# liberoCONFIG

## Release Notification 11. May 2021

liberoCONFIG & SmartStart version 2021.5.3.0

- Checksum is displayed in SmartStart application.

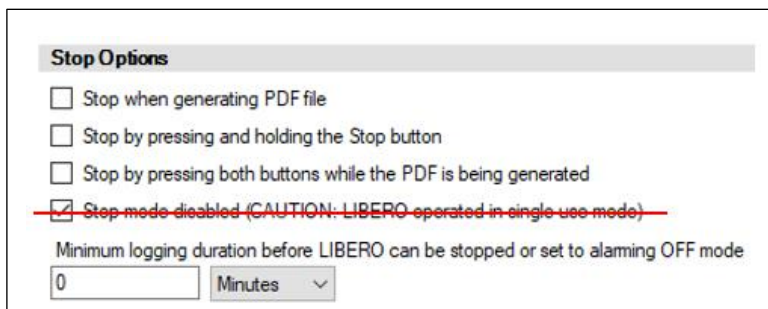
- Checksum not displayed

A SmartStart application being generated with liberoCONFIG 2020.12.2.0 does not show a checksum value (as usually displayed in previous versions).

Issues have been resolved, as a result:

Profile Checksum: 3.769.661.077
